## Statement of Facts and Contentions

Court	Land and Environment Court of NSW
Division	Class 1
Registry	Land and Environment Court Sydney
Case number	2025/00483319

First Applicant	Celesteem Turramurra Development Pty Ltd
First Respondent	Ku-ring-gai Council ABN 86408856411

The Respondent says that the facts relevant to the determination of the Development Application (Council Application number: eDA0470/25) (Portal Application number: PAN-565172) (Sydney North Planning Panel: PPSSNH-727) ("**the Development Application**") are as follows:

*Image 01: Screenshot of the ground floor Level*

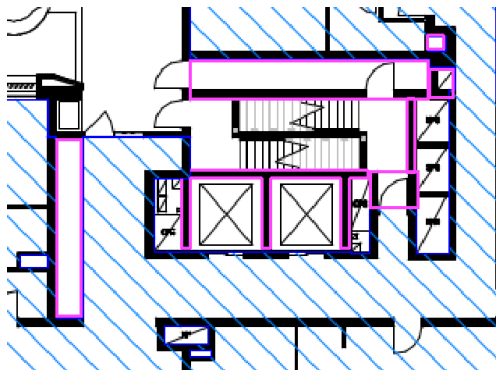
- a) The areas of GFA that have been incorrectly excluded are identified in the screenshot below (highlighted in pink):

- b) The thickness of internal walls enclosing common vertical circulation (e.g. lifts and stairs), as well as the thickness of walls to risers, must be included in the GFA calculation.

- c) The maintenance storage area proposed adjacent to UG02 must also be included in the GFA.
- d) Clarification is also required regarding the area labelled as “service” on the left-hand side of the lifts, including how this area meets the exclusion criteria for GFA.

*Image 03: Screenshot of Level 4*

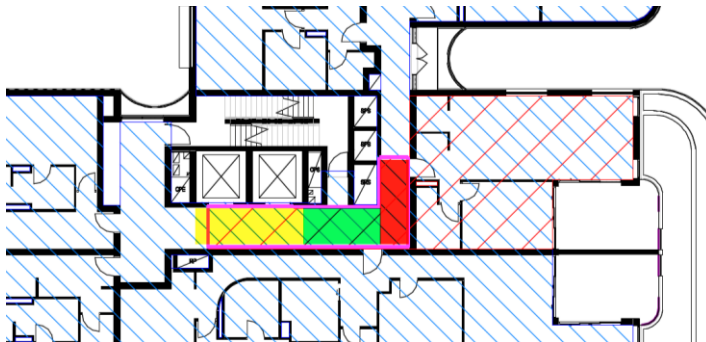
- f) The submitted FSR diagrams (DA400F) show two coloured hatched areas (red and blue). It appears that the red hatching is intended to represent the GFA allocated to the affordable housing units. The common areas serving all units on a level cannot be solely attributed to the affordable housing GFA.

- g) The pink-outlined area on Level 4 serves all units on that floor and therefore should not be allocated exclusively to the affordable unit GFA. The following is noted on Level 4:

- i. The yellow-hatched area serves 6 units, including the affordable units
  - ii. The green-hatched area serves 4 units, including the affordable units

- iii. The red-hatched area serves 3 units, including the affordable units

- h) This issue occurs on multiple levels where affordable units are proposed.
- i) A more accurate and proportionate allocation method must be applied to confirm that the proposed development provides the required affordable units in accordance with Chapter 2 of the Housing SEPP.
- j) This information may affect the extent of the allowable increase in the maximum building height in accordance with Chapter 2 of the Housing SEPP.
